NUCLEAR REGULATORY COMMISSION (NRC) – BELLEFONTE NUCLEAR
PLANT (BLN) – CHANGES TO ENVIRONMENTAL REPORT CHAPTER 8 – NEED
FOR POWER

ENCLOSURE 1
CHANGES TO BLN ENVIRONMENTAL REPORT CHAPTER 8-NEED FOR POWER
May 30, 2008

**CHANGES TO
BELLEFONTE COLA, PART 3
ENVIRONMENTAL REPORT
CHAPTER 8 - NEED FOR POWER**

FIGURE 8.2-9
Regional vs. National Economic Growth

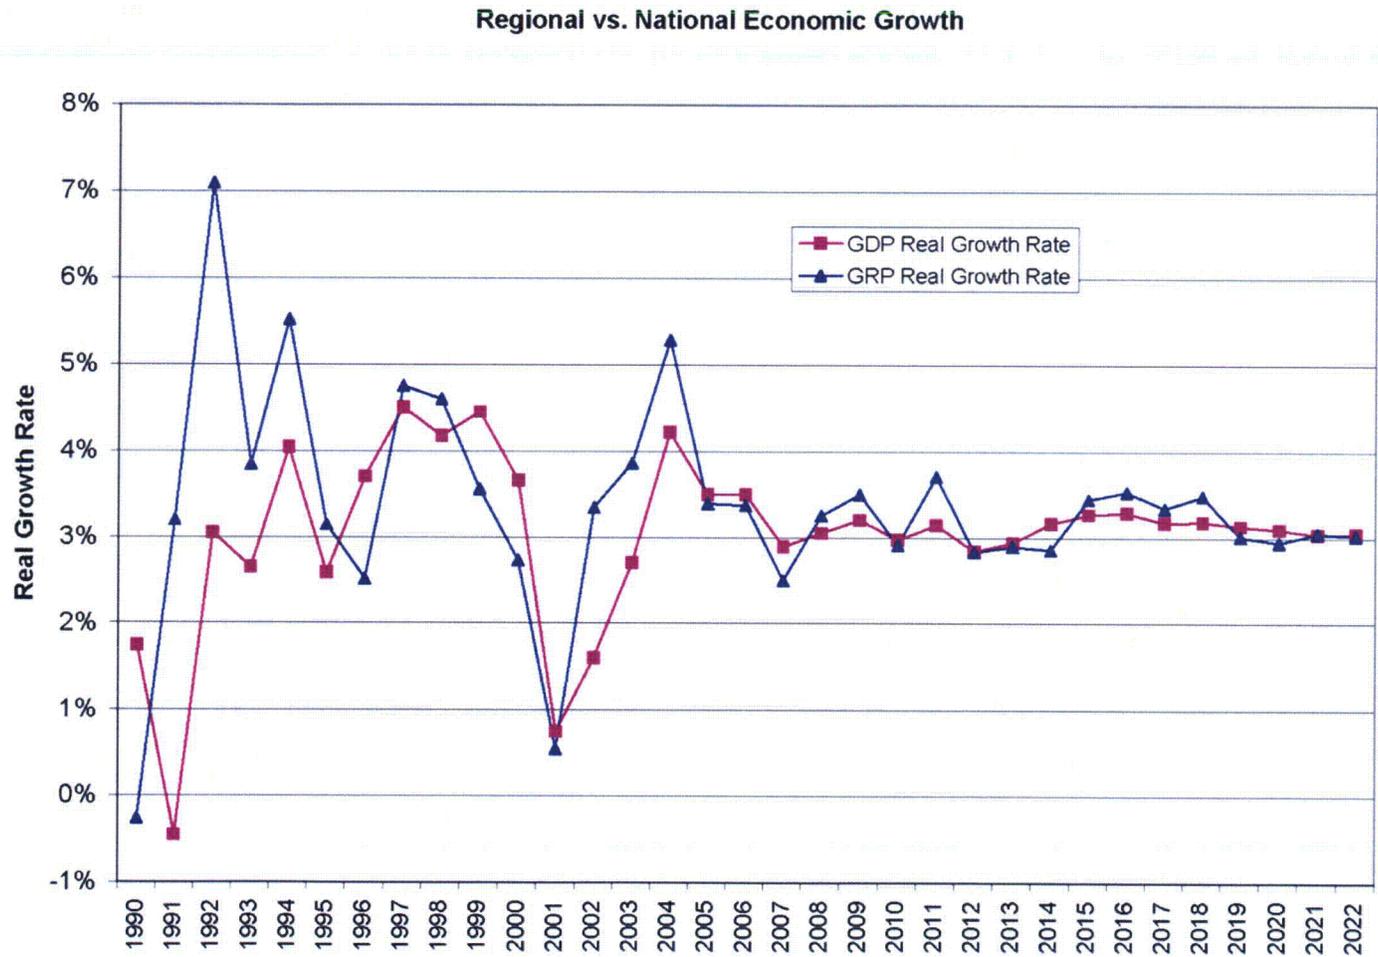
- Figure 8.2-9 is updated with current regional and national economic growth projections. These changes do not affect the corresponding text in Chapter 8.
- Table 8.2-5 is updated with current growth regional product (GRP) projections. Two values are updated: GRP for 2012-2017 and GRP for 2017-2022. These changes do not affect the corresponding text in Chapter 8.
- Table 8.2-7 is updated with current socioeconomic projections. Ten values are updated: all household and population values for 2012-2017; all household data for 2017-2022; and population data for the medium forecast for 2017-2022. These changes do not affect the corresponding text in Chapter 8.
- Table 8.2-8 is revised to include the Low forecast values that were inadvertently omitted from Table 8.2-8. These changes do not affect the corresponding text in Chapter 8.

5. Replace Figure 8.2-9 with the following figure:

FIGURE 8.4-9
Reduction in SO₂ Emissions due to BLN Unit 3 (2018) and BLN Unit 4 (2019)

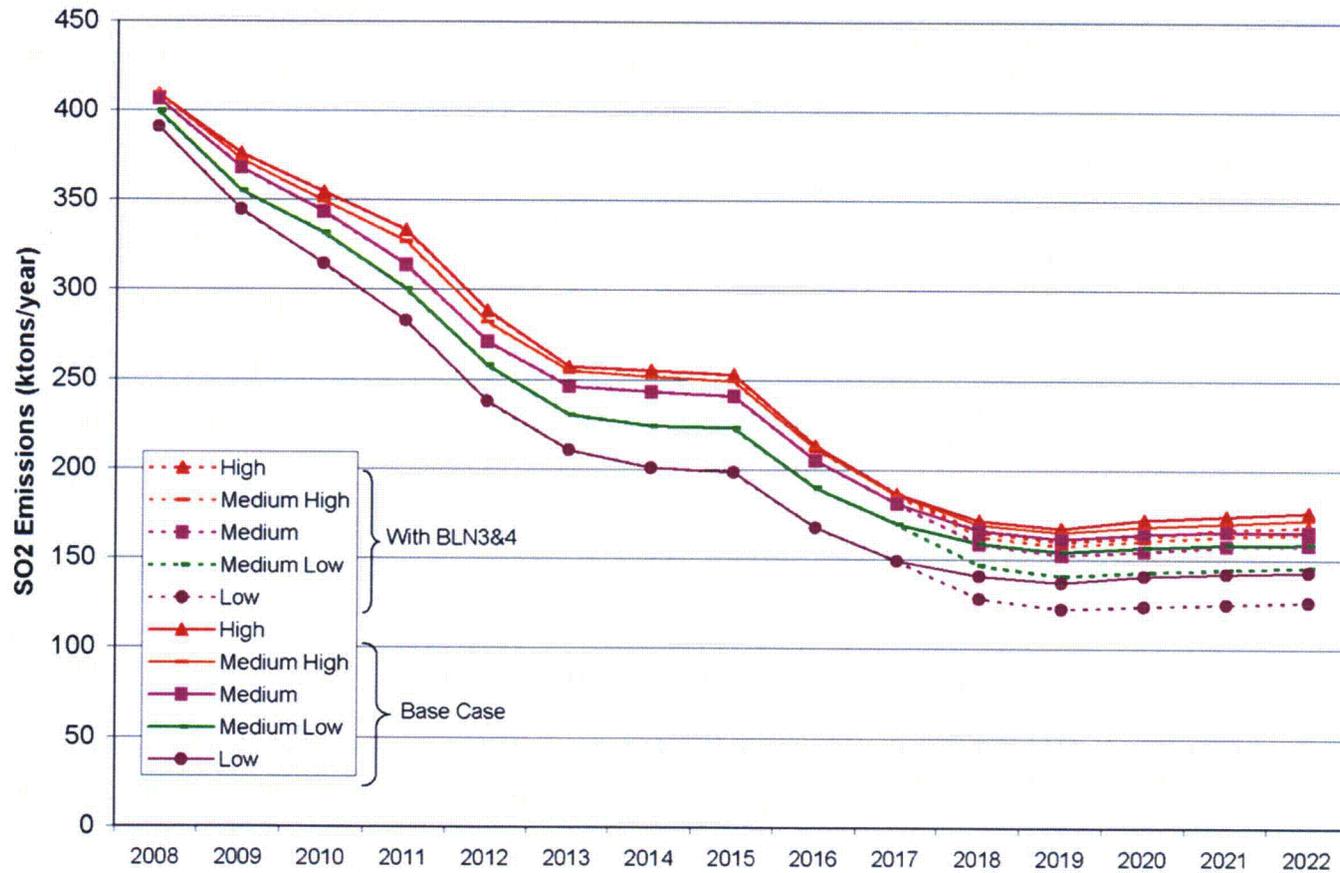
- Figure 8.4-9 is replaced with a revised figure. This is an editorial change to remove incorrect emissions projections (i.e., dashed lines). These changes do not affect the corresponding text in Chapter 8.
- Table 8.4-1 is updated with revised emissions reduction projections. These changes do not affect the corresponding text in Chapter 8.

7. Replace Figure 8.4-9 with the following figure:
